# Pentium® Processor Specification Update

Release Date: October, 1996

Order Number: 242480-022

The Pentium processor may contain design defects or errors known as errata. Characterized errata that may cause the Pentium processor's behavior to deviate from published specifications are documented in this specification update.

## 21. *Power-Up BIST Failure*

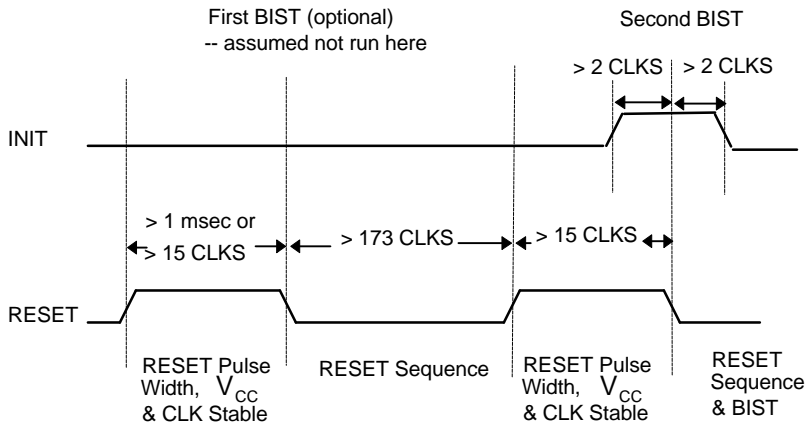
**PROBLEM:** The BIST (Built In Self Test) feature may fail.

**IMPLICATION:** Upon completion of BIST, a false failure may be reported. That is, a non-zero value may be returned in the EAX register, even though the part is operating correctly. As such, this erratum has no other product or system implications and is fully functional. To date, all observed false failures have returned a value of 20000H in EAX.

**WORKAROUND:** The root cause of the failure is not yet fully understood. As a result, workarounds suggested in this document are not guaranteed to fix the problem. To Intel's knowledge, however, no BIST failures have been observed with use of either of the workarounds.

1. Invoke a double RESET — All false BIST failures have occurred during cold RESET. In order to accurately execute BIST, a double RESET sequence may be performed as shown in the figure below:

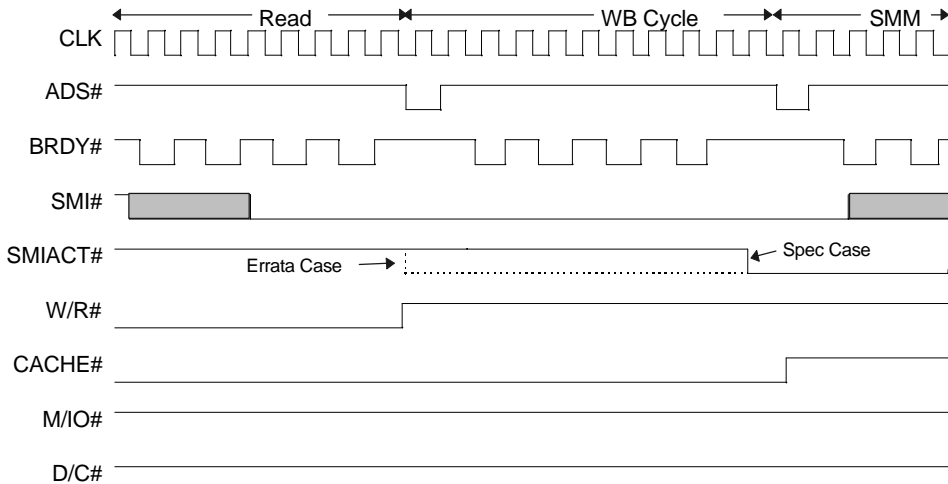
**PROBLEM:** Under rare circumstances, a BOFF# asserted to the processor, while it is internally waiting (looping) for the completion of all pending bus cycles, may cause the processor to proceed with the event before all pending bus activity is completed. However, bus cycle ordering will not change.

<i>Stop Grant special cycle</i>	If BOFF# is used to back off a Stop Grant special cycle, the processor may hang. Stop Grant and Stop Clock states for low power consumption cannot be used.
<i>AutoHALT special cycle</i>	If BOFF# is used to back off a AutoHALT special cycle, the processor may hang. This means that the lower power AutoHALT state is not usable. This does not affect the normal HALT state, entered with the HLT instruction though.
<i>INIT asserted while there is a memory mapped APIC register access</i>	If BOFF# is used to back off a memory mapped APIC register access (read or write) while an INIT is pending, the processor may hang. The INIT would only be used during a switch from Protected to Real mode, which is normally associated with a system reboot. In the processor lockup occurs a reboot may have to be performed via system powerdown.

**WORKAROUND:** Restrict the use of BOFF# for the described events. In addition, the SMI# pending event can be eliminated by locating SMRAM so that it does not shadow standard memory and does not require SMIACT# for memory decode. The OUT or Serializing instruction events are also eliminated if the next instruction does not depend on the result of the event before executing the instruction. The Stop Grant special cycle event is also eliminated by not asserting STPCLK#. The AutoHALT special cycle event is also eliminated by disabling AUTOHALT (set TR12.AHD bit to '1').

## 11. ***Future Pentium® OverDrive® Processor FERR# Contention in Two-Socket Systems***

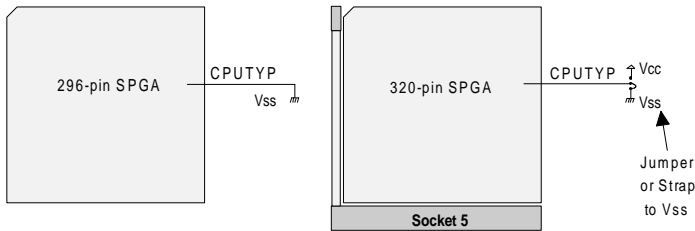
**PROBLEM:** When the future Pentium OverDrive® processor is plugged into Socket 5 of a two socket 75-, 90-, or 100-MHz Pentium processor system, the OEM processor shuts down following RESET to allow the OverDrive processor to drive the bus. In this case, the FERR# output of the 75-, 90-, and 100-MHz Pentium processor continues to be driven HIGH (inactive).

1. **For upgradability in two socket systems:** External logic may be used to connect the FERR# outputs from the two sockets (296-pin SPGA and 320-pin Socket 5) in a way that will resolve the signal contention. An external AND gate may be used to combine the outputs of the FERR# signals from the two sockets. A pullup resistor ( $\geq 3K\Omega$ ) is required on the FERR# output from both of the sockets in order to allow proper operation of both the dual processor and the future Pentium OverDrive processor. See the following figure:

2. **Upgradability by modifying a two socket system to be a single socket system:** This workaround involves modifying a design that includes two socket sites (296-pin SPGA and 320-pin Socket 5) such that it effectively becomes a single socket design.

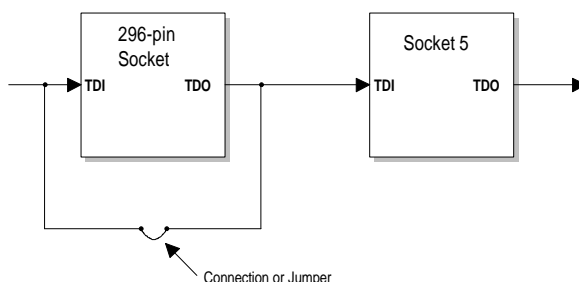
A dual processing two socket system must have CPUTYP tied to  $V_{SS}$  on the 296-pin SPGA OEM socket, and tied to  $V_{CC}$  on Socket 5 (320-pin SPGA). This workaround includes inserting a jumper on the Socket 5 CPUTYP signal (or strapping Socket 5 CPUTYP directly to  $V_{SS}$ ) to make this the primary processor site. The system would then effectively become a single-socket design. NOTE: If a jumper is used, it must be set by the OEM prior to system sale (not by the end-user at the time of the future Pentium OverDrive processor purchase and installation). This jumper would set the CPUTYP signal on Socket 5 to  $V_{SS}$ . If the same board design is used for dual processing, this jumper (or strapping option) may be set to  $V_{CC}$  for those systems, as shown in the following figure:

By setting CPUTYP to  $V_{SS}$ , and inserting the 75-, 90-, and 100-MHz Pentium processor into Socket 5 prior to system sale, the design can be treated as if it is a single socket system. When upgrading with the future Pentium OverDrive processor, the 75-, 90-, and 100-MHz Pentium processor is removed from Socket 5 and replaced by the OverDrive processor upgrade.

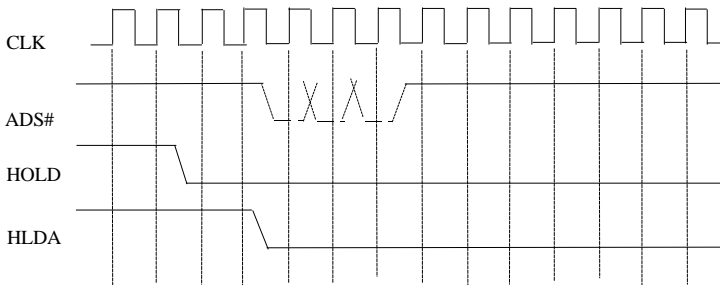
**PROBLEM:** The *Pentium Processor Family Developer's Manual*, Volume 1 states that the TAP Hi-Z state can be terminated by resetting the TAP with the TRST# pin, by issuing another TAP instruction, or by entering the Test\_Logic\_Reset state. However, the indication that the processor has entered the TAP Hi-Z state is maintained until the next RESET. Therefore by using the above methods alone, the TAP Hi-Z state can not be terminated.

**IMPLICATION:** When the TAP Hi-Z instruction is enabled and executed, using the methods described in the *Pentium Processor Family Developer's Manual*, Volume 1 may not terminate the Hi-Z state.

**WORKAROUND:** To exit TAP Hi-Z state, in addition to the methods described above, the processor needs to be RESET as well.

Pending Cycle May Be Delayed

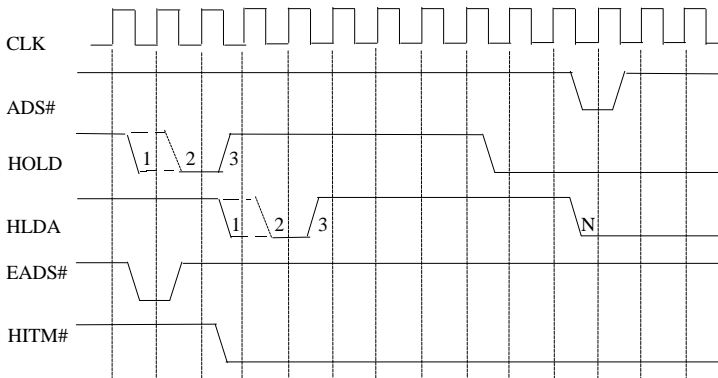
In two cases, for example, if HOLD is deasserted for one clock (i.e., clock 2) or two clocks (i.e., clocks 1 & 2) and then reasserted, the window may not be large enough to start a pending snoop writeback cycle. The writeback cycle may be delayed until the HLDA is deasserted again (i.e., clock N). See diagram below.

### **3DP. External Snooping with AHOLD Asserted May Cause Processor to Hang**

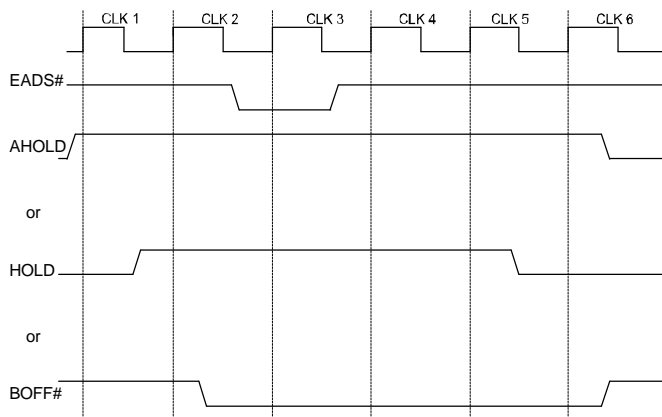
**PROBLEM:** The following sequence of events may cause one of the processors in a dual processing system to hang:

**IMPLICATION:** If a memory write or memory read cycle is pending on the bus and an external snoop occurs, one of the processors may hang.

1. Ensure that NA#/BRDY# is asserted before, or after the "critical period". (the critical period is the two CLK period after EADS# is sampled active.)  
or
2. Ensure that AHOLD is held high for a minimum of three clocks after EADS# has been sampled active. See the following figure.  
or
3. Drive HOLD for two clocks after the EADS# was sampled active. Removal of HOLD can be done without regard to the HLDA signal. See the following figure.  
or
4. Drive BOFF# for 3 clocks after the EADS# was sampled active. See the following figure.

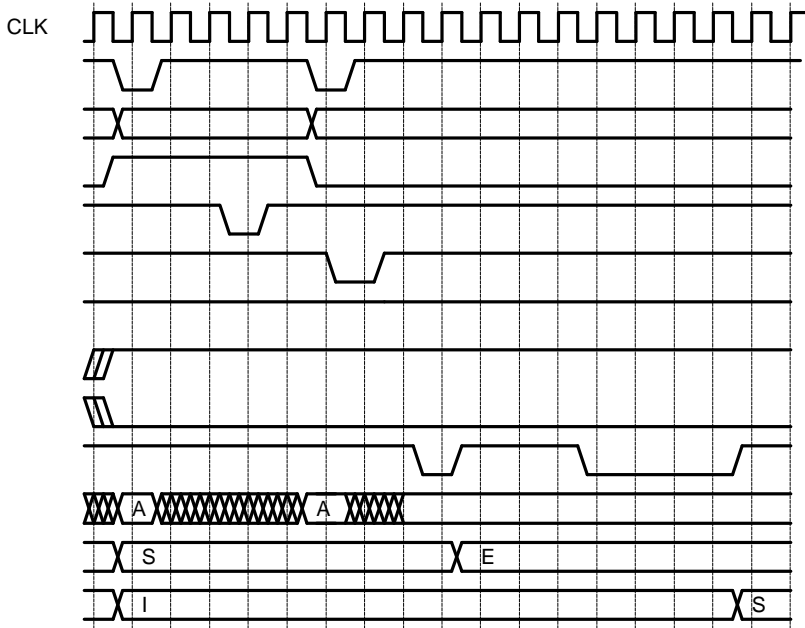
**PROBLEM:** This is a dual processor erratum: There is a very short setup and hold time for the address bus lines in Dual Processing mode to support the single clock interprocessor snoop response required for cache coherency. In this case the 3ns setup specification is enough for the address to propagate to the cache but it does not allow enough time for the address to propagate to the parity calculation circuits. There is a chance that the APCHK# line will spuriously go active showing a parity error on the address bus.

**IMPLICATION:** Internal measurements of these address signals show that if the 3ns spec is met, the addresses will be latched correctly. Since the parity portion of the circuitry does not meet this timing there is no way to guarantee the APCHK# output is valid. Systems using the APCHK# pin will perform the APCHK# interrupt error routines.

**WORKAROUND:** Designs based on the 82430NX PCIset and other chip sets which ignore APCHK# in a dual processor environment are therefore not affected. If the address setup ( $t_{83}$ ) and Maximum Valid Delay ( $t_6$ ) timings in the *Pentium Processor Family Developer's Manual*, Volume 1, Section 23.4.5.2 and 23.4.5.3 are followed, this erratum will not apply to C-step components and future steppings.

**CASE 1:**

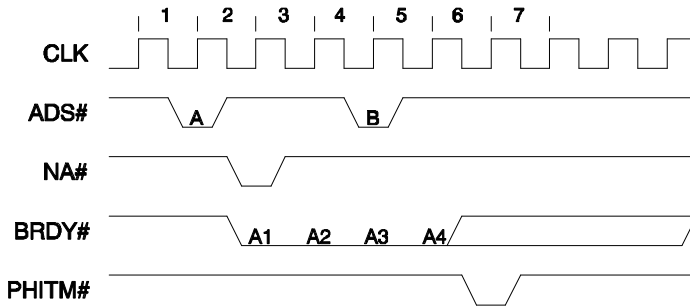
For this erratum to occur, either of two specific sequence of conditions must occur on the bus as shown in the figures below:

- The processor issues read cycle A which may be pipelined into an earlier (not shown) cycle.
- Cycle A will be completed by the system as a 2-1-1-1 (zero wait state) cycle.
- One clock after issuance of the ADS#, NA# is asserted by the system.
- A pipelined cycle (B) is asserted by the MRM in clock 4.
- Cycle A completes on the bus in clock 5.
- One clock later, PHITM# is issued by the LRM.

**CASE 2:**

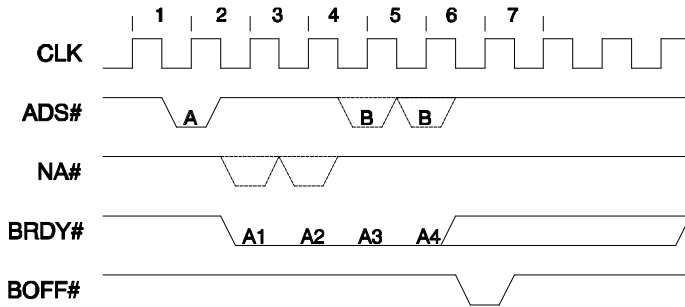
- The processor issues read cycle A which may be pipelined into an earlier (not shown) cycle.
- Cycle A will be completed by the system as a 2-1-1-1 (zero wait state) cycle.
- One or two clocks after issuance of the ADS#, NA# is asserted by the system.
- A pipelined cycle (B) is asserted by the MRM in either clock 4 or clock 5.
- Cycle A completes on the bus in clock 5.
- One clock later, BOFF# is issued by the system.

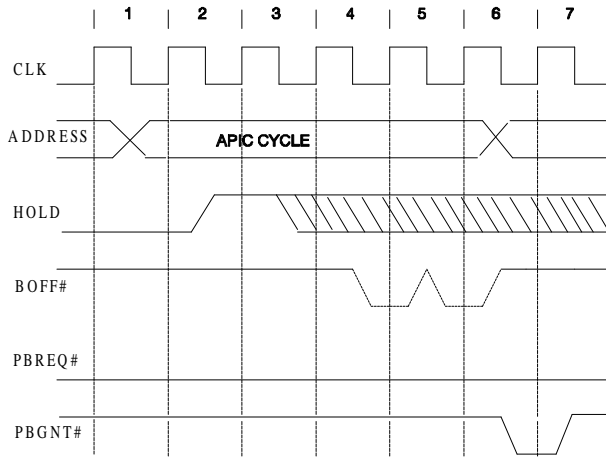
**IMPLICATION:** The specification states that EADS# is ignored while the processor is driving the bus. Occurrence of this erratum means that unnecessary invalidations and writeback cycles may be performed resulting in sub-optimal performance.

**WORKAROUND:** The system should not assert EADS# while the CPU owns the bus. Designs based on the 82430NX PCIset and other chip sets which do not assert EADS# while the CPU owns the bus are therefore not affected.

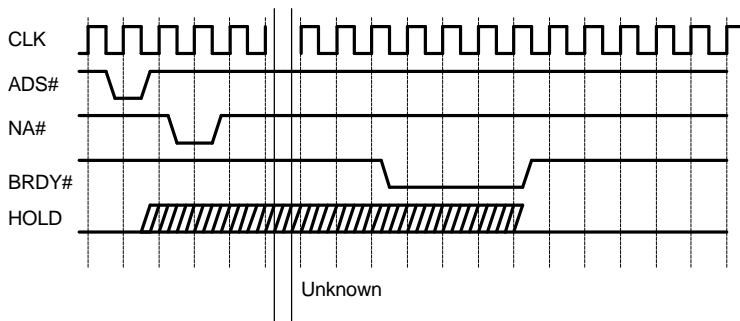
**PROBLEM:** If the processor is reading one of its local APIC registers when the HOLD pin is asserted, PCHK# may be asserted for one clock even though there is no data parity error. PCHK# will be asserted if the values of the data bits [D31:0] and the parity bits [DP3:DP0] do not match during the HOLD/HLDA transaction.

**IMPLICATION:** This will impact a system that implements or responds to parity checking by the CPU, the response will be specific to the parity error recovery routines implemented in the system. If parity is not implemented in a system, there will be NO adverse effect from this erratum since there is no real parity problem.

**WORKAROUND:** If data parity checking and the local APIC are both enabled, deassert PEN# (parity enable) during the time that HOLD is active. This signals to the processor that parity is not being driven from the system and PCHK# will never be driven in response to this data transfer.

## 28. PPGA Package Dimensions

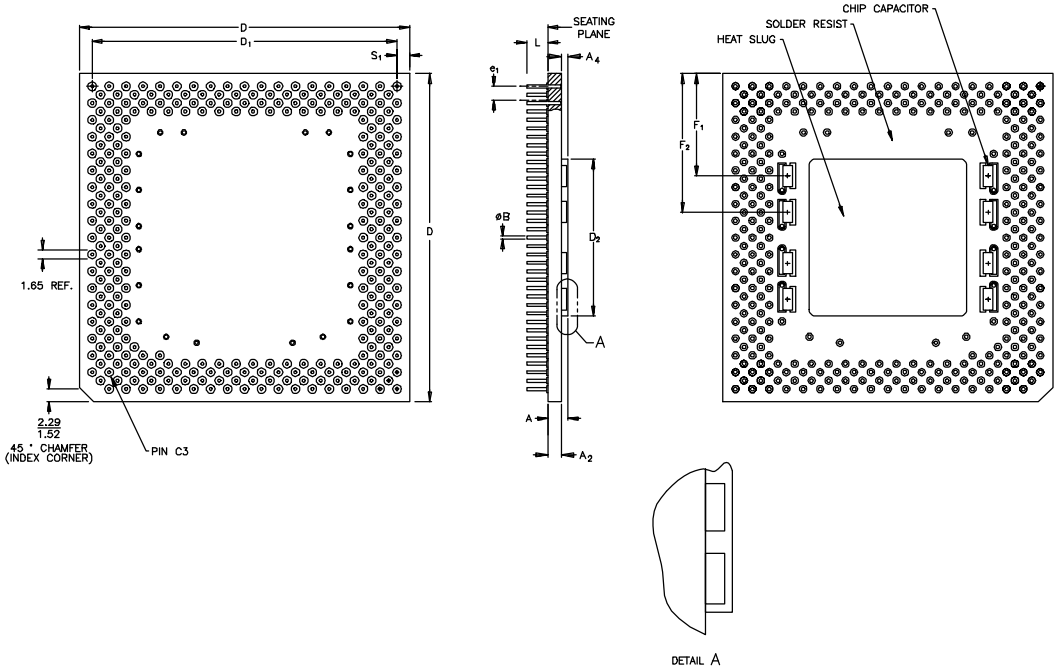
Package dimensions for the Plastic Pin Grid Array (PPGA) package are as follows. This information will be added to the *Pentium Processor Family Developer's Manual*, Volume 1, Chapter 25.

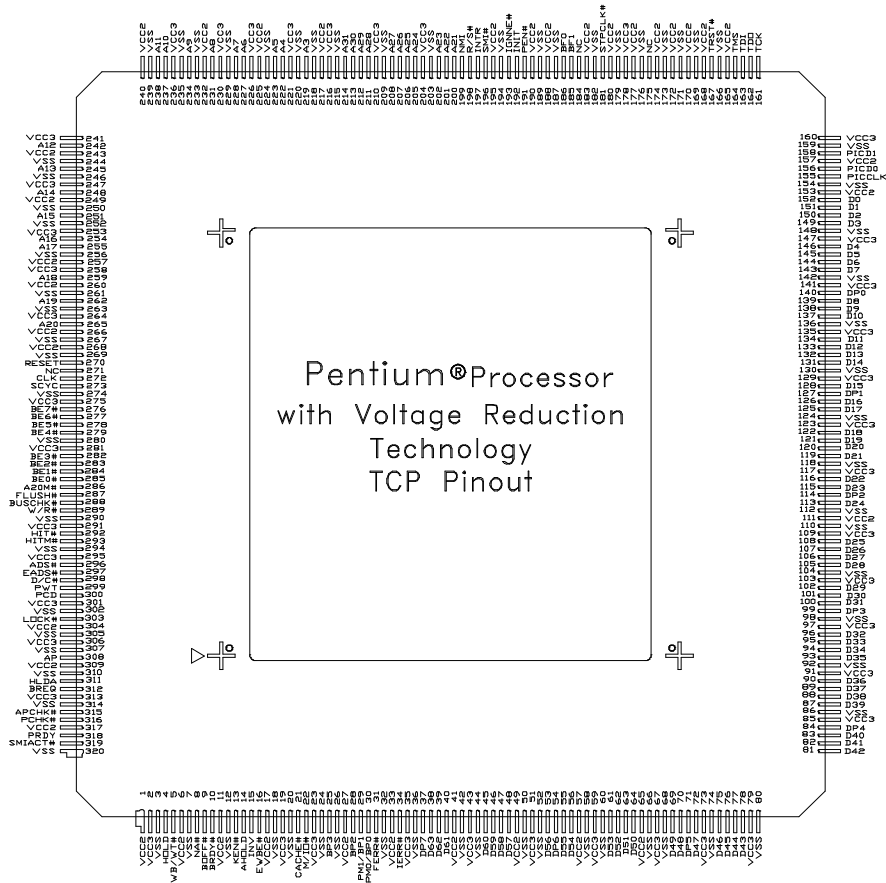
The TCP pinout drawing on page 8 of the Pentium Processor with Voltage Reduction Technology Data Sheet was inadvertently rotated. The correct orientation is shown below.
